<b>ITEM: 6.17</b>	<b>REPORT SUMMARY MINOR VARIANCE APPLICATION FILE NUMBER A130/24</b>
-------------------	--

## MINOR VARIANCE APPLICATION FILE NUMBER A130/24

<b>CITY WARD #:</b>	5
<b>APPLICANT:</b>	Rafael Alter
<b>AGENT:</b>	Edward Broeders & Evan Baard
<b>PROPERTY:</b>	143 Thornridge Drive, Thornhill
<b>ZONING DESIGNATION:</b>	See below.
<b>VAUGHAN OFFICIAL PLAN (2010) DESIGNATION:</b>	Vaughan Official Plan 2010 ('VOP 2010'): "Low-Rise Residential"
<b>RELATED DEVELOPMENT APPLICATIONS:</b>	None
<b>PURPOSE OF APPLICATION:</b>	Relief from the Zoning By-law is being requested to permit a proposed pool.

1 SITE PLAN:  
1:150

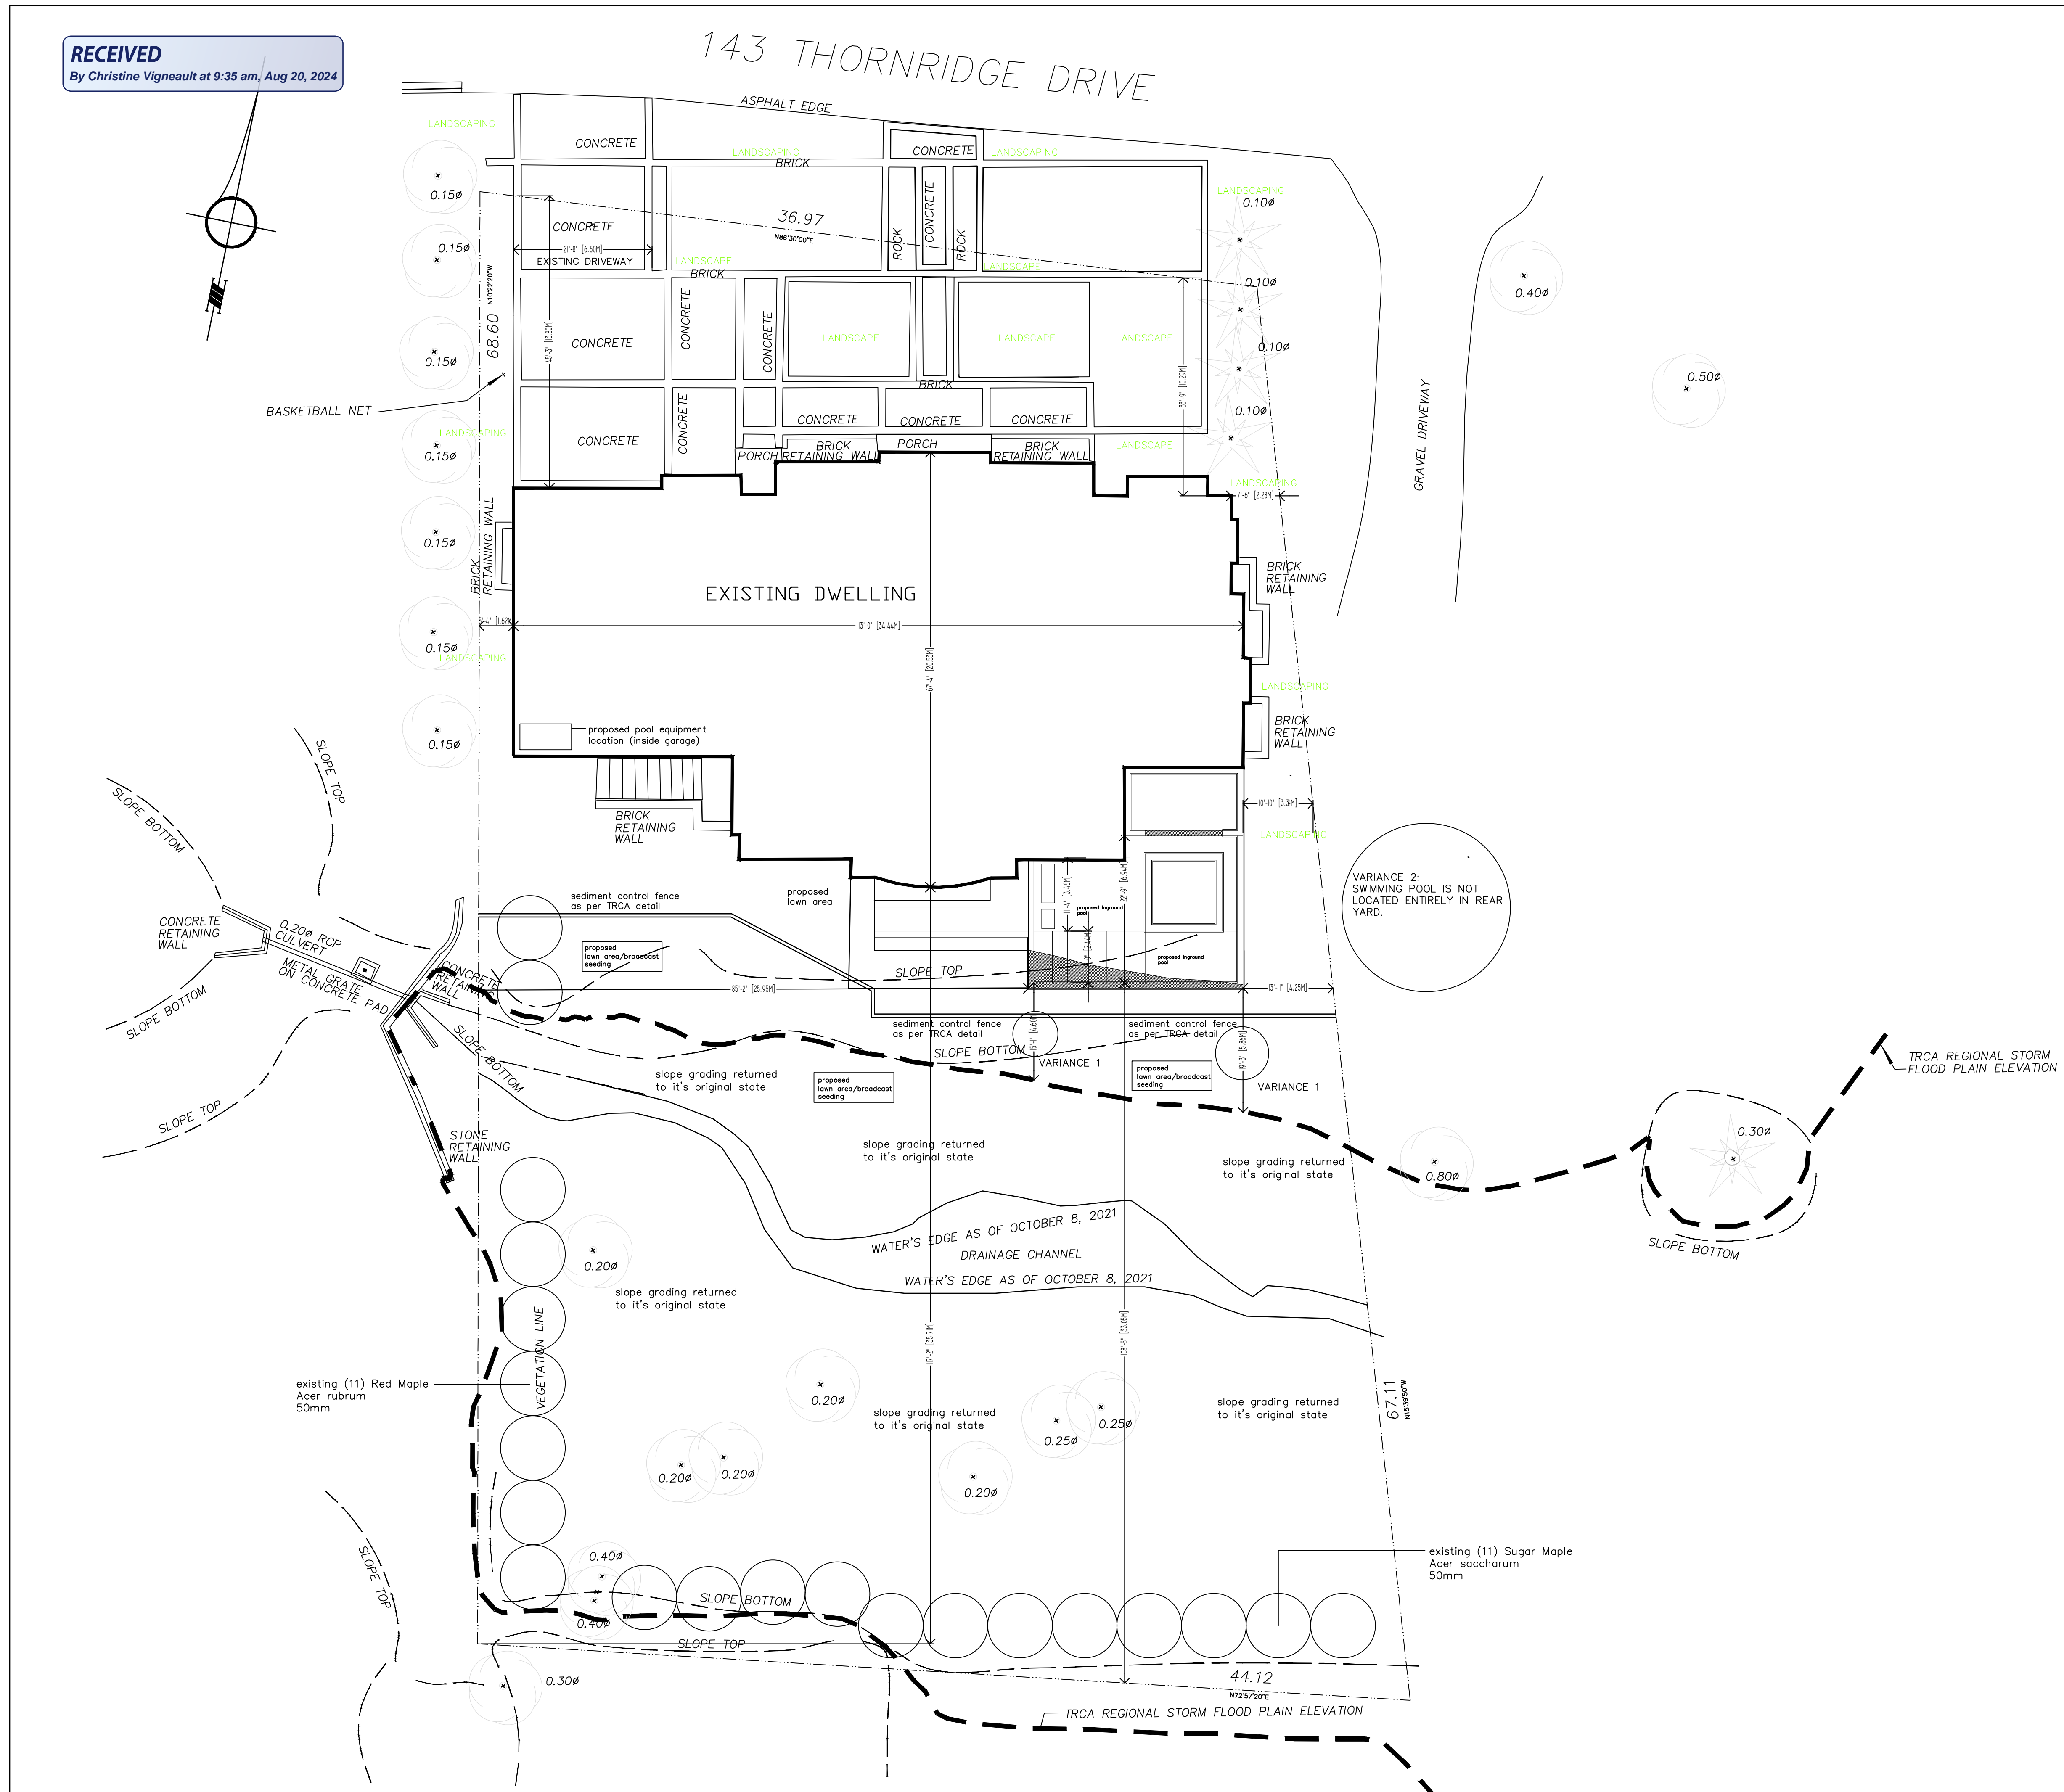
General Comments	
1	The applicant shall be advised that additional variances may be required upon review of detailed drawing for building permit.
2	The subject lands may be subject to Ontario Regulation 166/06 (TRCA - Toronto and Region Conservation Authority).
3	The walkway in front of the dwelling extends onto municipally owned lands. An Encroachment Agreement may be required. Please contact the Clerk's Department for discussion.

TRCA staff have reviewed and issued a permit for the proposed in-ground pool (TRCA Permit No. CFN 70830, issued June 14, 2024). The plans submitted with this application are consistent with the plans that were approved as part of TRCA's permit.

**MINIMUM VERTICAL & HORIZONTAL CLEARANCES OF CONDUCTORS FROM BUILDINGS OR OTHER PERMANENT STRUCTURES (CONDUCTORS NOT ATTACHED TO BUILDINGS)**

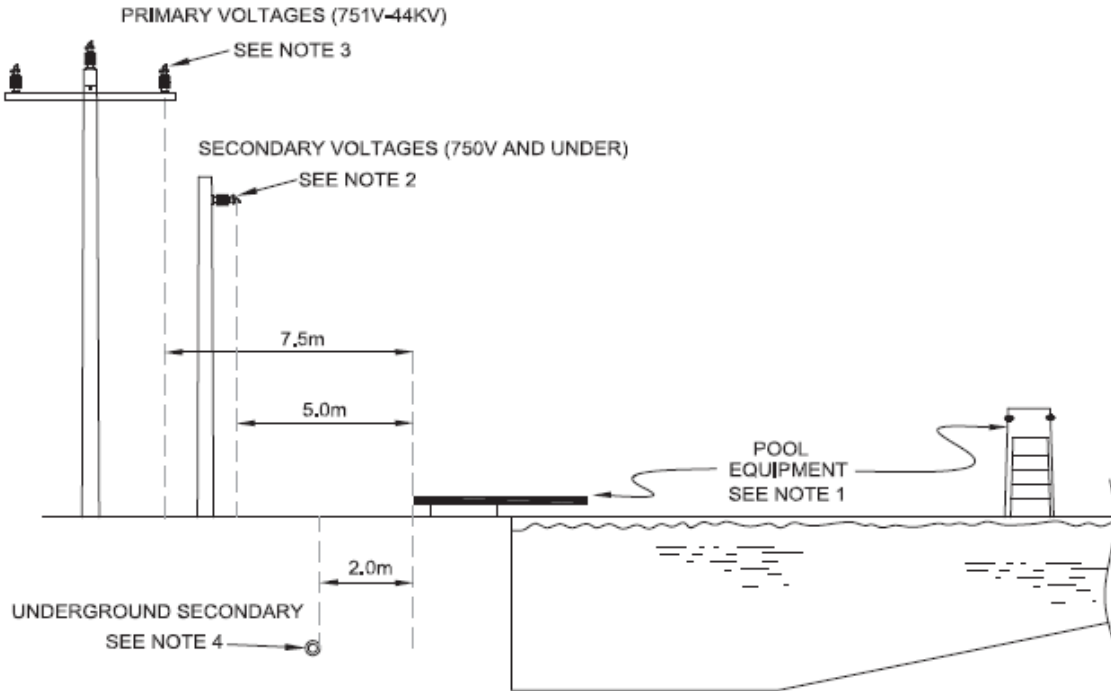
All proposed billboards, signs, and other structures associated with the project or plan must maintain minimum clearances to the existing overhead or underground electrical distribution system as specified by the applicable standards, codes and acts referenced.

1. UNDER NO CIRCUMSTANCES SHALL A CONDUCTOR BE PERMITTED TO PENETRATE THE ENVELOPE SHOWN BY THE DOTTED LINE.
2. THE VERTICAL CLEARANCES ARE UNDER CONDITIONS OF MAXIMUM DESIGN SAG.

3. THE HORIZONTAL CLEARANCES ARE UNDER CONDITIONS OF MAXIMUM SWING. WHERE THE CONDUCTOR SWING IS NOT KNOWN A HORIZONTAL CLEARANCE OF 480CM SHALL BE USED.
